REPORT TO THE CALGARY PLANNING COMMISSION

| | DP NO: | DP2011-1307 |

PROPOSAL:
New: Apartment building, Live-work units, Retail store (2 buildings, 642 units, 2 phases)

**GROUND LEVEL
 LANDSCAPE EAST**

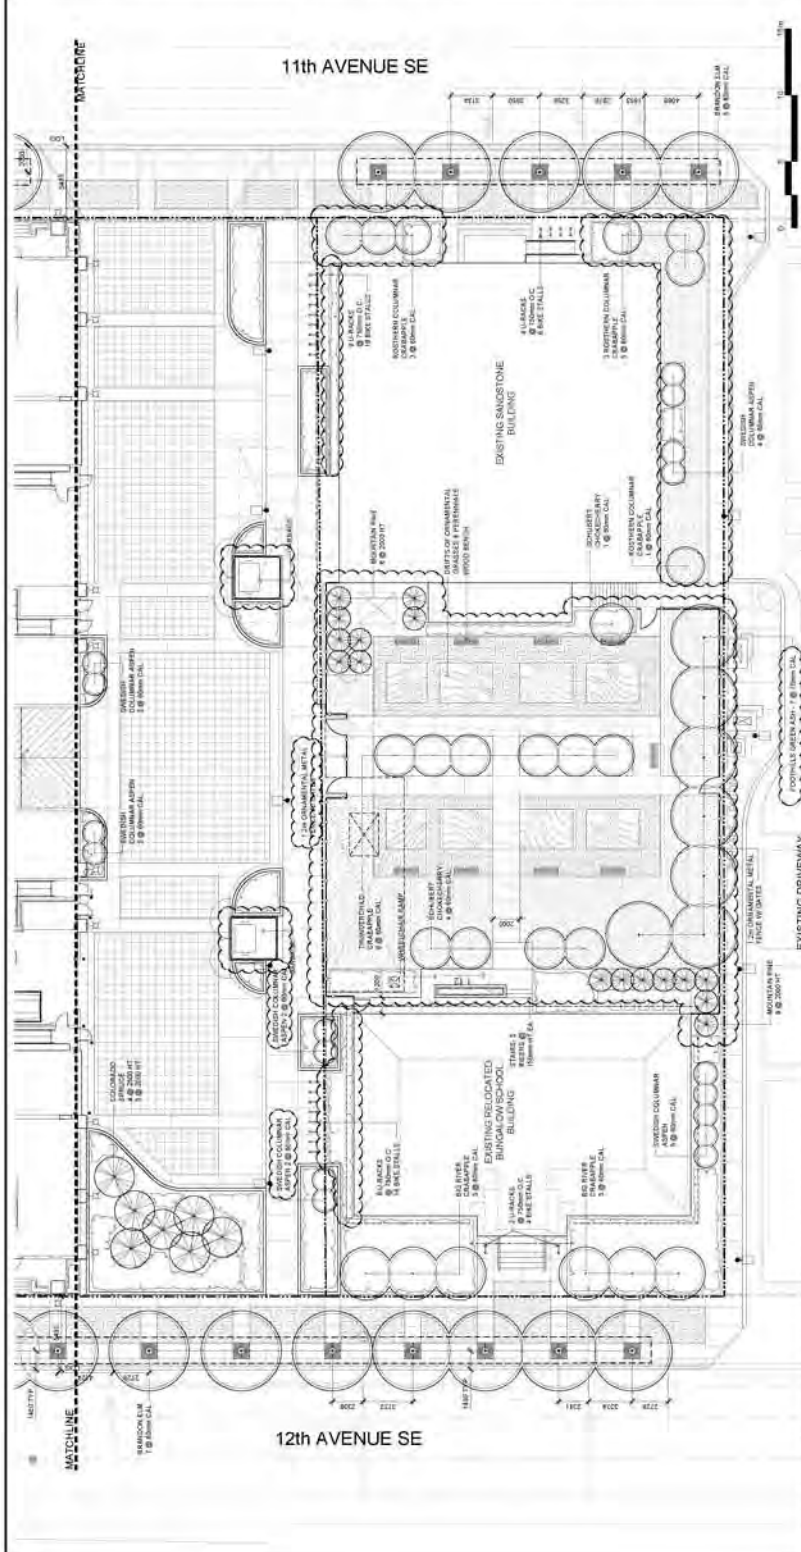
5. Amend the Site Plan (A.03), Level 1 Plan (A1.5), Landscape Plan (L1.0), Landscape Plan West (L1.1), and Landscape Plan East (L1.2) to be consistent in the location of 64 Class 2 bicycle (short-stay) parking stalls. Ensure all bicycle parking stalls are located outside of the clear walking width of all public sidewalks.

LANDSCAPE DETAILS

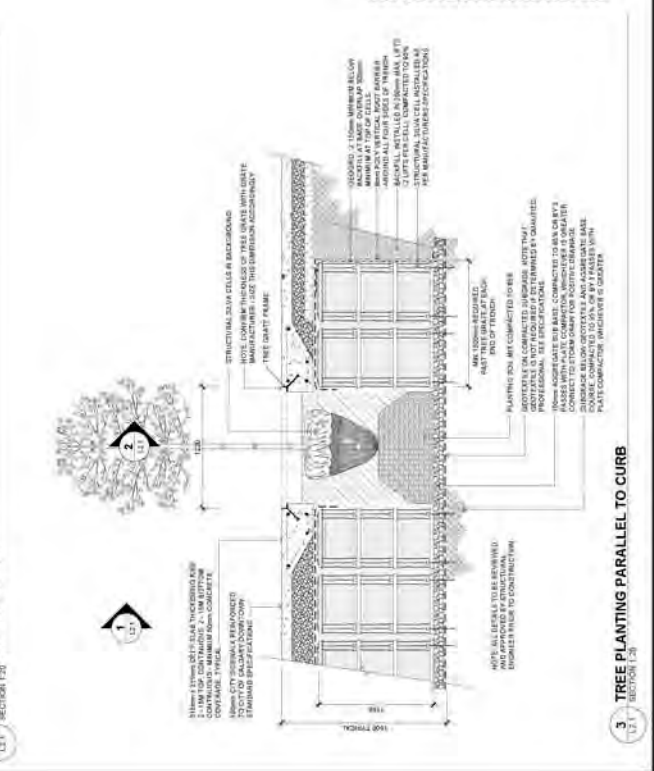
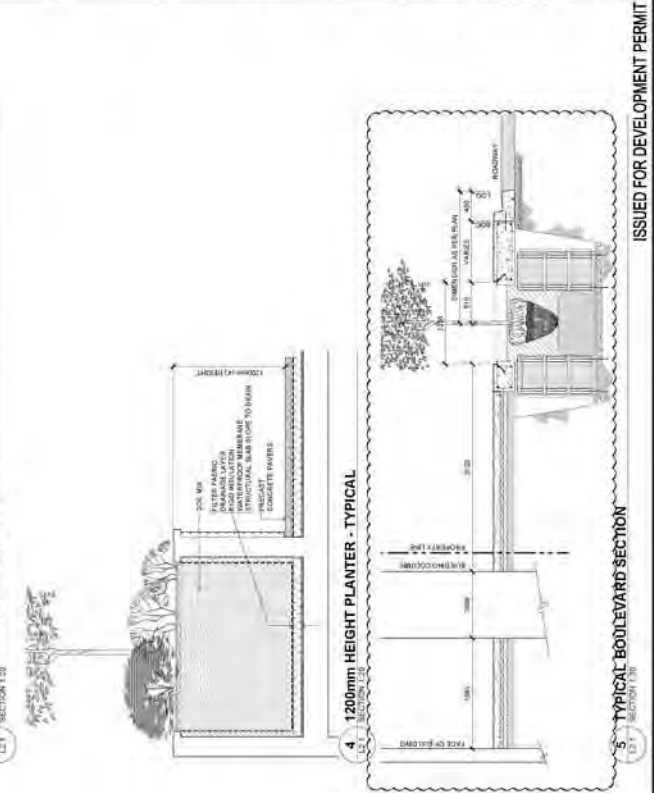
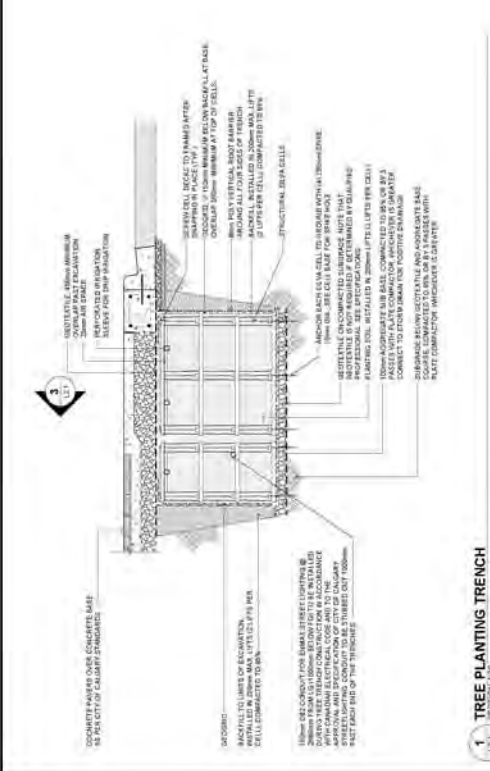
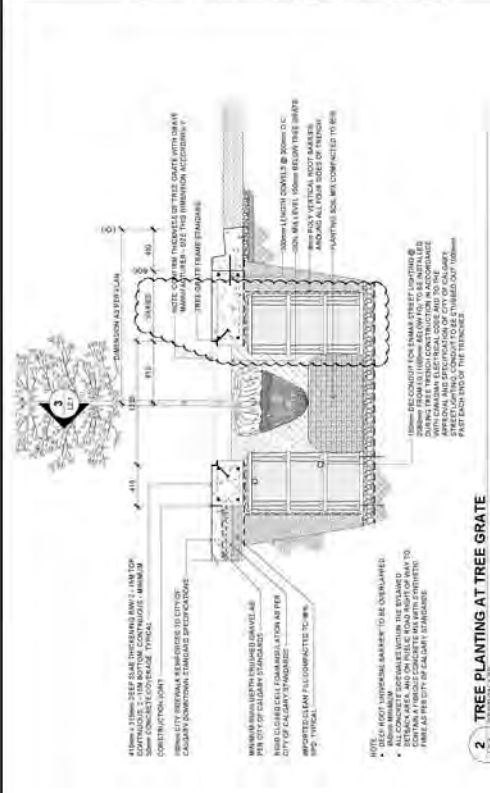
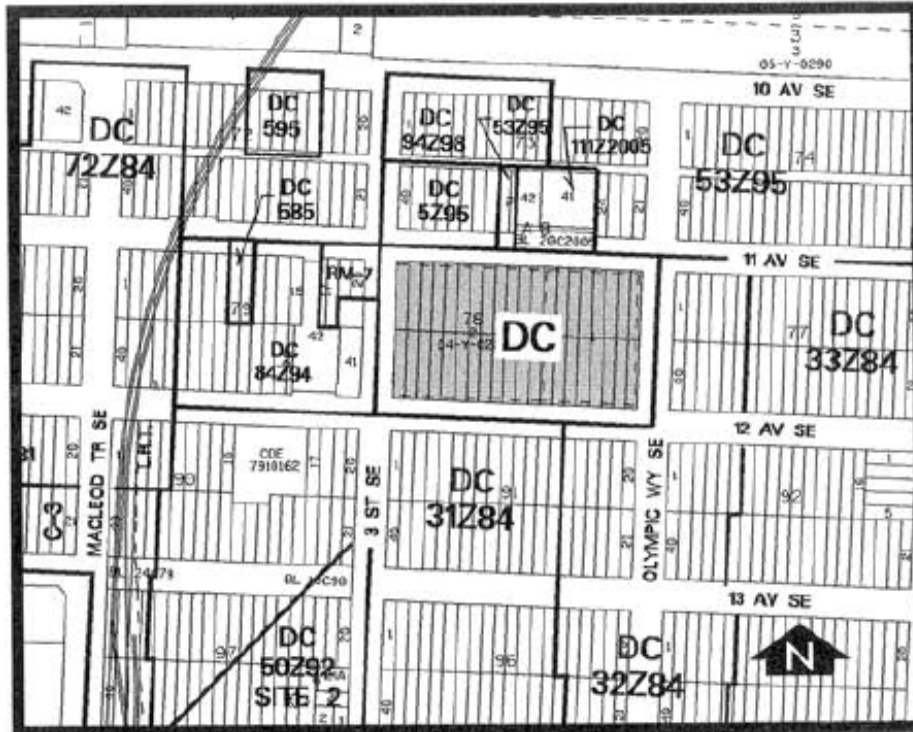
7. Provide 75 millimeter bark mulch on top of street tree planting soil mix as per Parks Development Guidelines and Standard Specifications Landscape Construction (current edition) and indicate on Details 2, 3 and 5/L2.1.
